Docket No. 50-29

Subject: FEMA ANALYSIS OF THE PROMPT ALERT AND NOTIFICATION  
SYSTEM FOR THE YANKEE ROWE NUCLEAR POWER STATION

YANKEE NUCLEAR POWER STATION  
SITE-SPECIFIC OFFSITE RADIOLOGICAL EMERGENCY  
PREPAREDNESS ALERT AND NOTIFICATION SYSTEM  
QUALITY ASSURANCE VERIFICATION

FIGURE 3

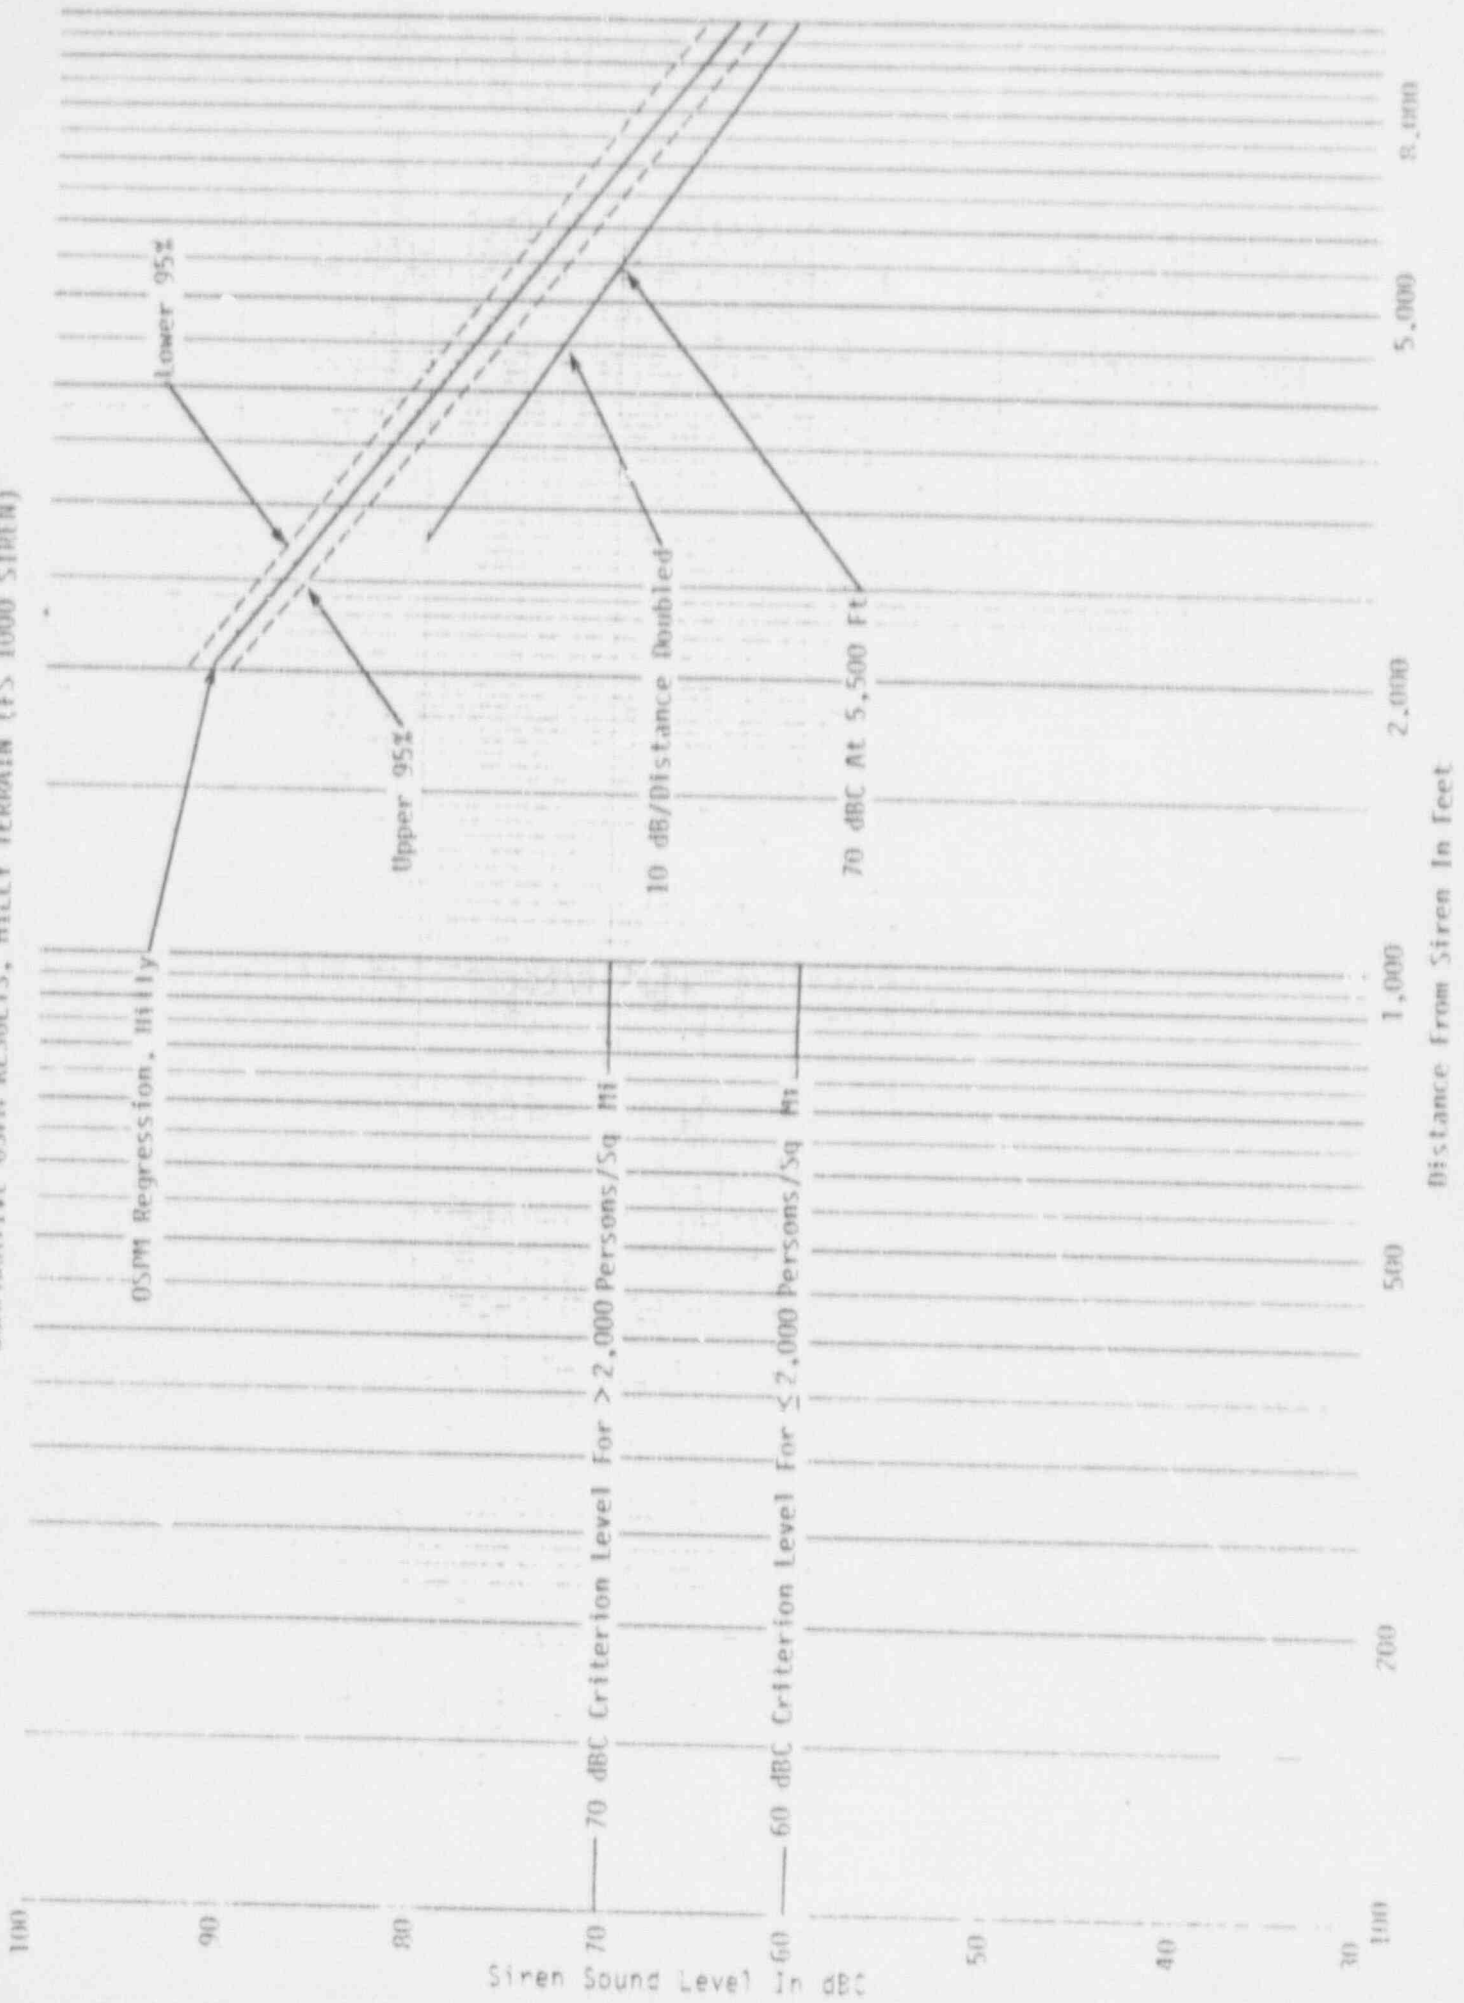
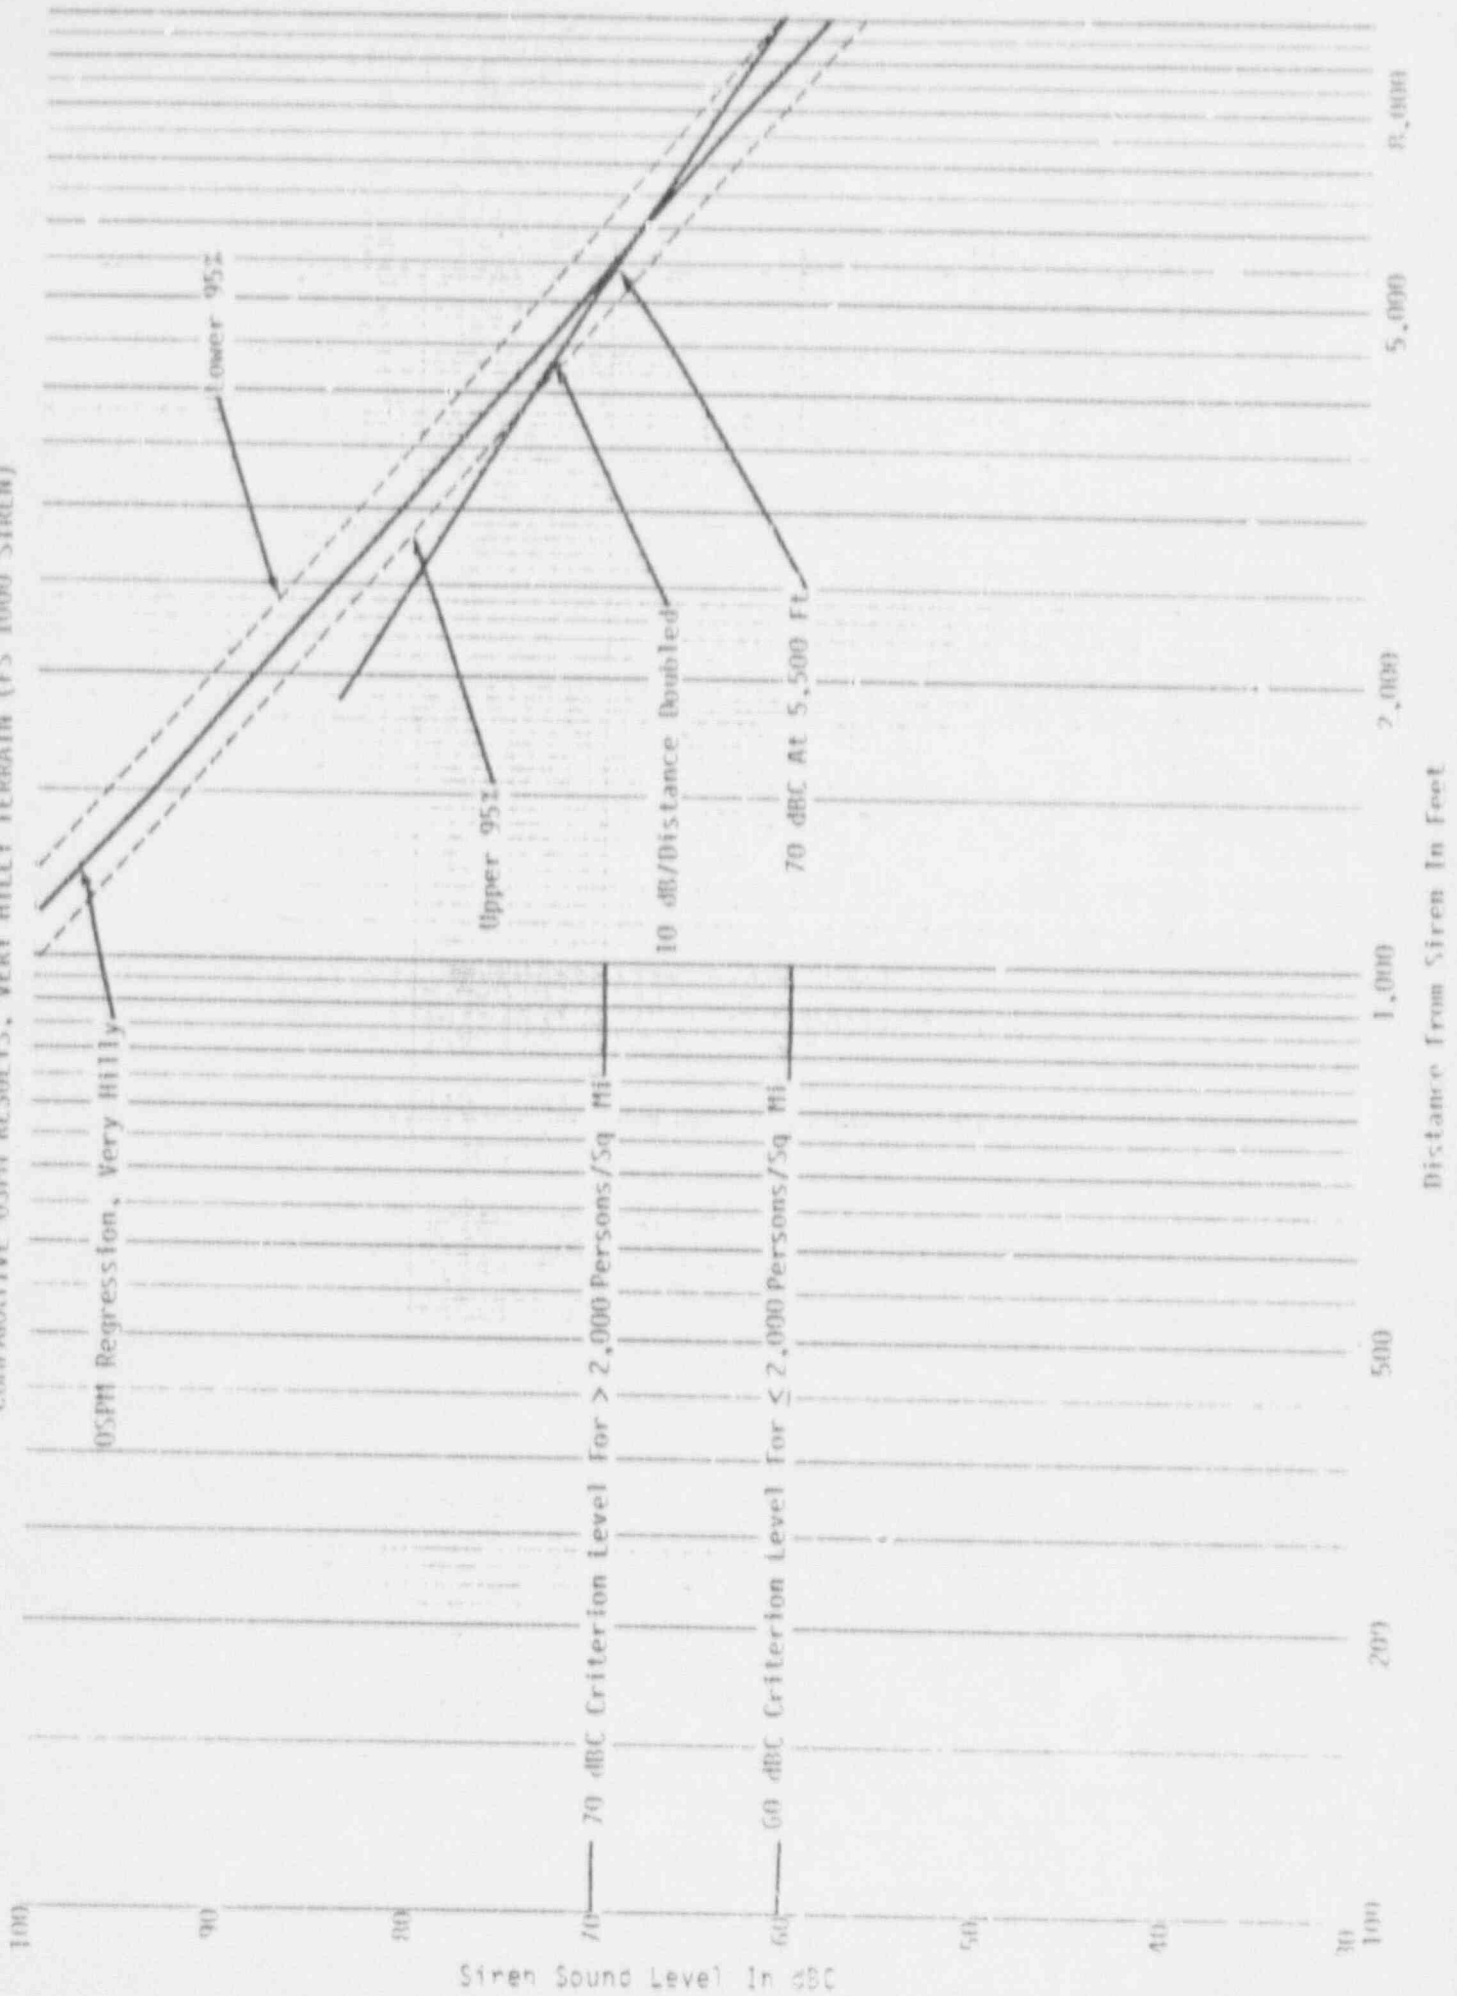
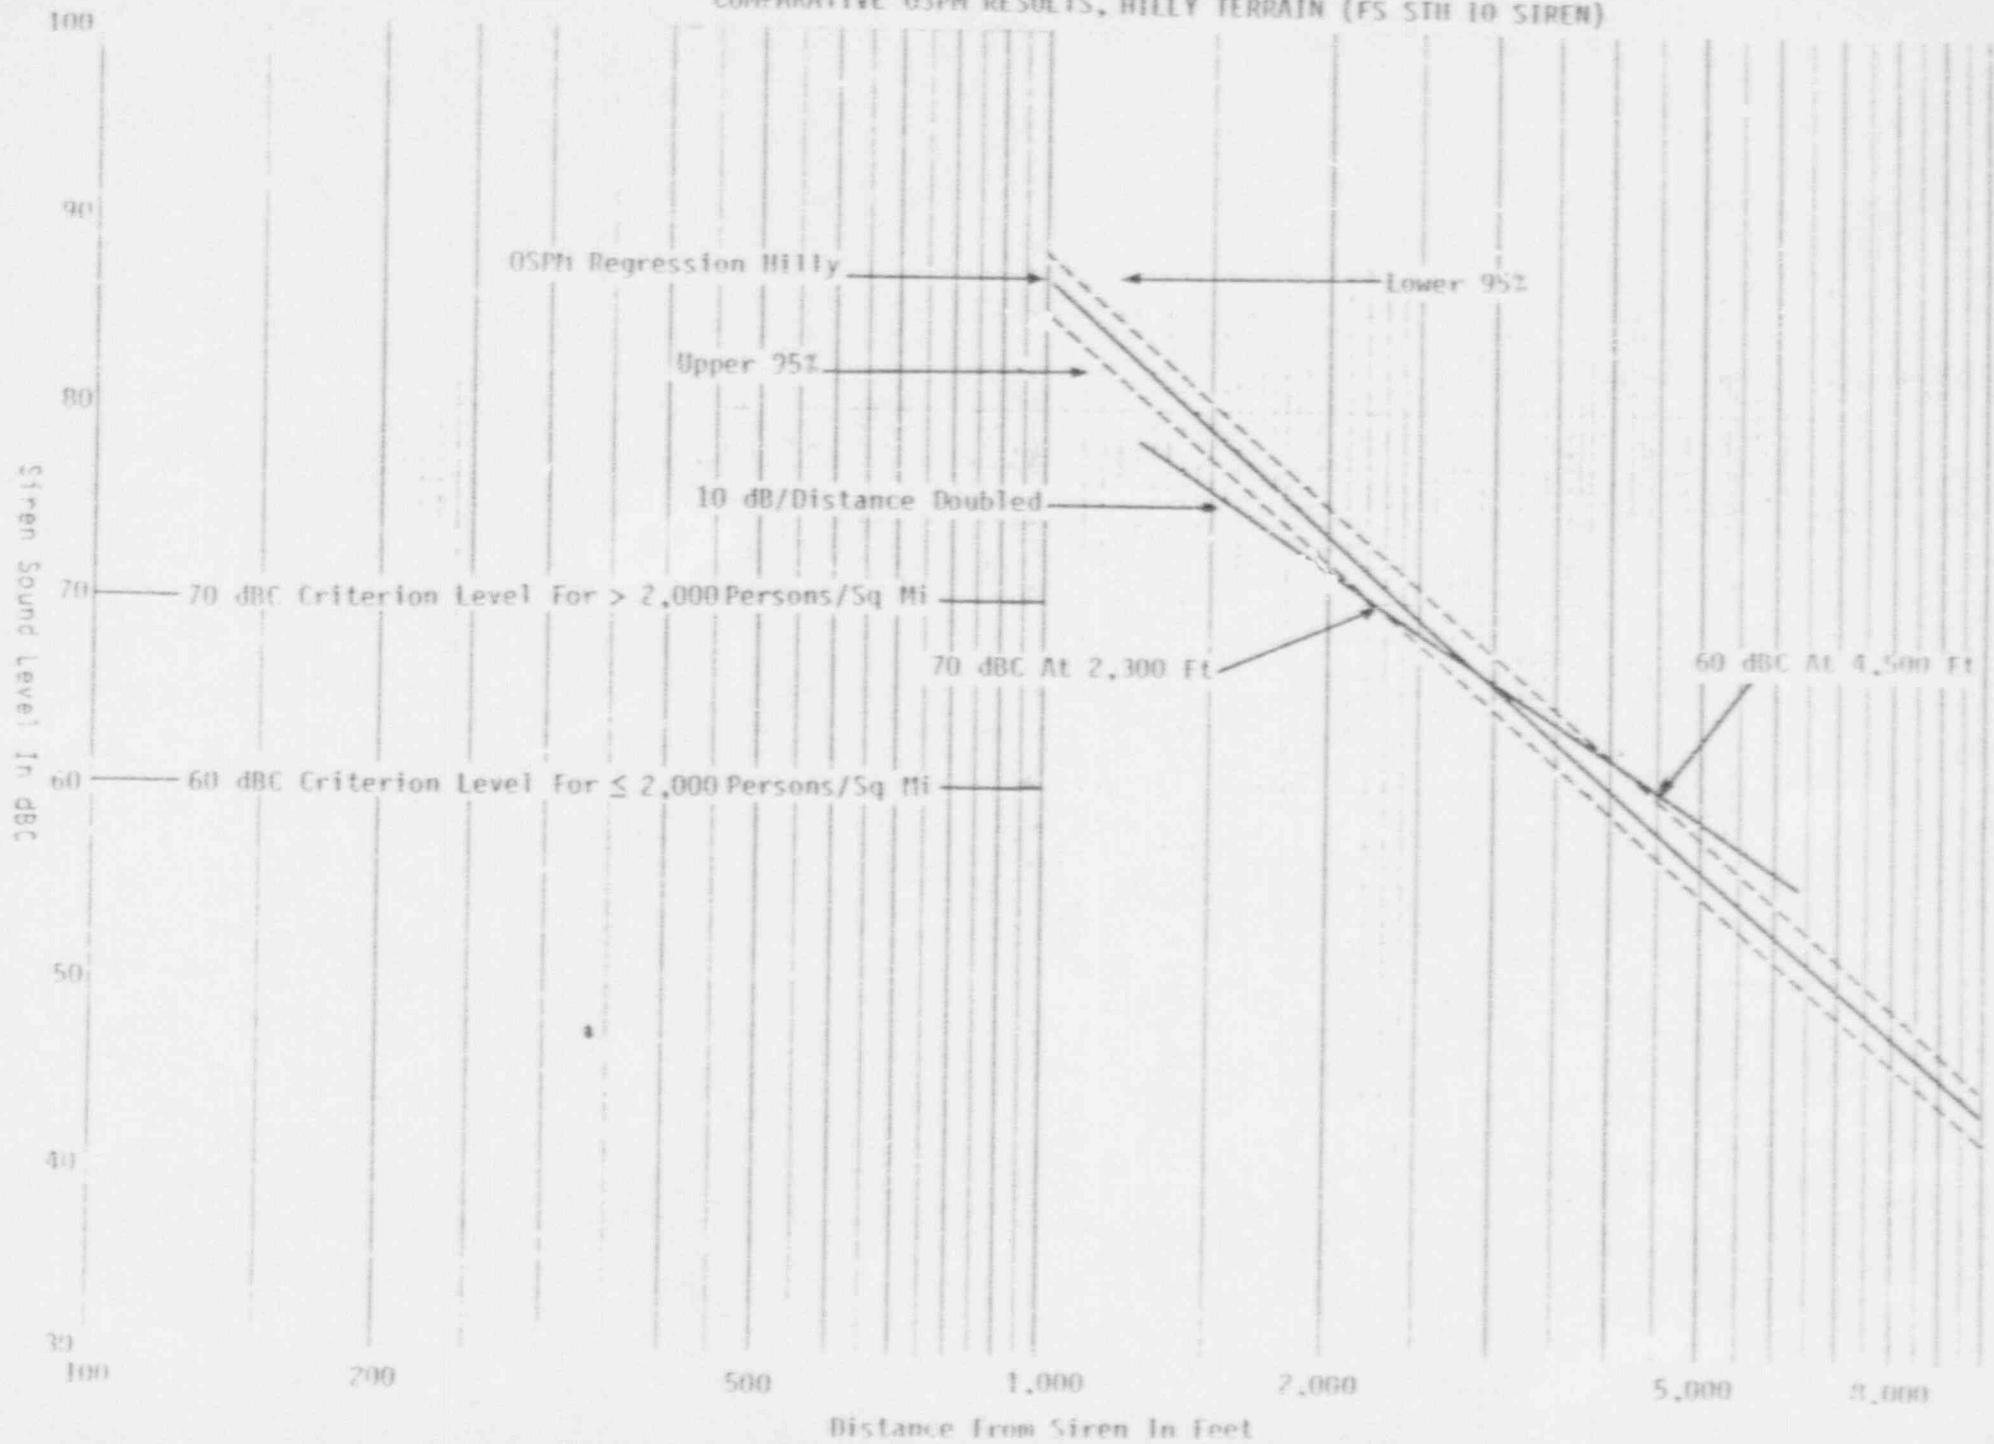
It was demonstrated by OSPM that essentially all of the populated areas within the EPZ of the USGS North Adams quadrangle map are expected to have a minimum siren sound pressure level of 60 dBC, and the area (City of North Adams) with more than 2,000 persons per square mile is expected to have a minimum siren sound pressure level of 70 dBC.

Comparisons of the OSPM-predicted 60 dBC and 70 dBC contours with the contours in the figures on pages 3-2-8 and 3-4-13 (Appendix 3) of the Design Report indicate that the coverage of the sirens as presented in the Design Report for North Adams is adequate.
